environmental statement

related to operation of

VERMONT YANKEE NUCLEAR POWER STATION

JULY 1972

Fig. III-16
Schematic Of Radioactive Gaseous Waste System
Vermont Yankee Nuclear Power Station

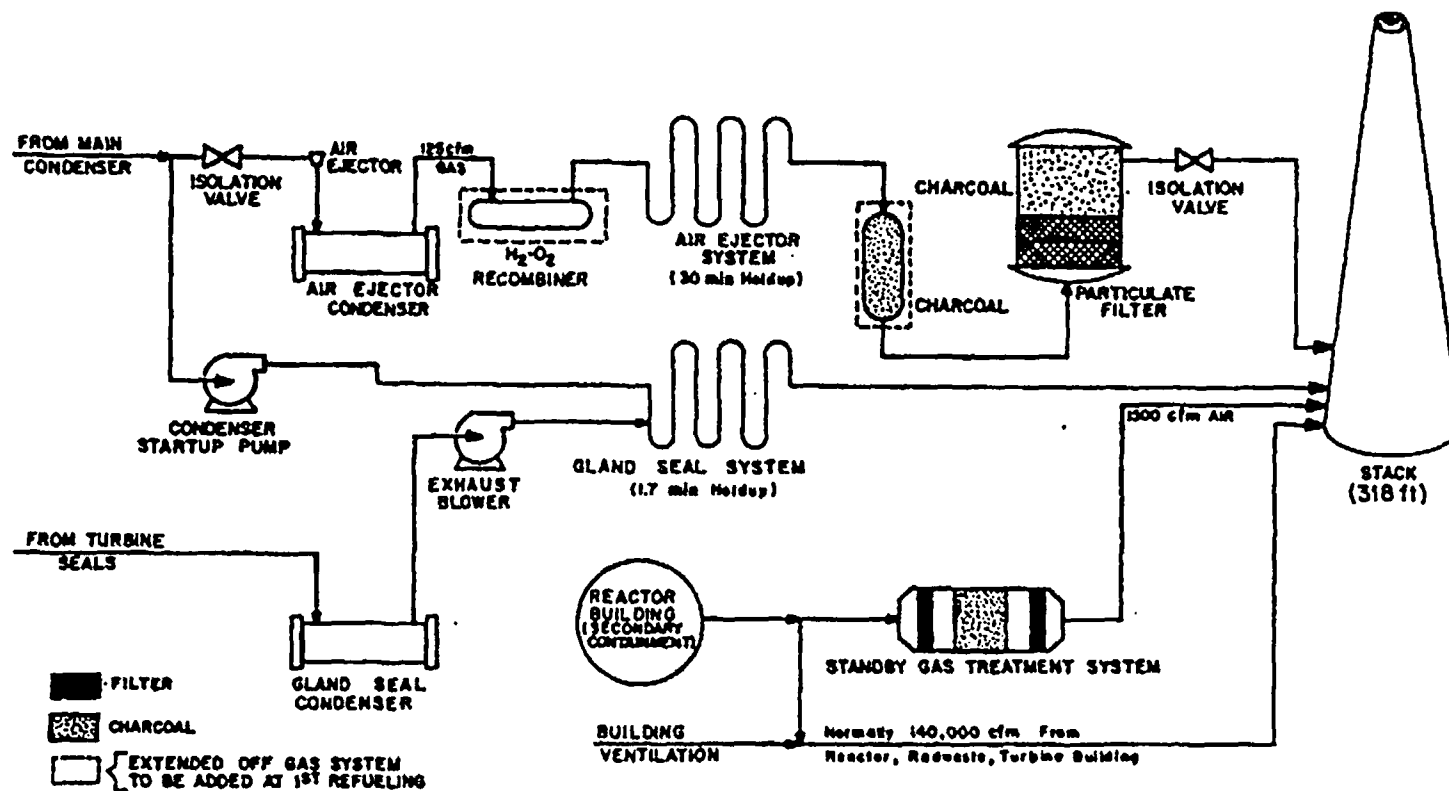
In addition, Figure III-16 (page 67) accurately shows the presence of a charcoal filter in the existing off-gas system discharge path. The text does not indicate whether or not the presence of this filter has been considered in the I-131 release estimate of 53.9×10^{-3} uCi/second during the period of operation prior to modification of the off-gas system. (Although a complete discussion of source term assumptions has not been provided, it appears to Vermont Yankee that the filter was not considered to remove iodine.) It is suggested that this subject be addressed in the final statement.
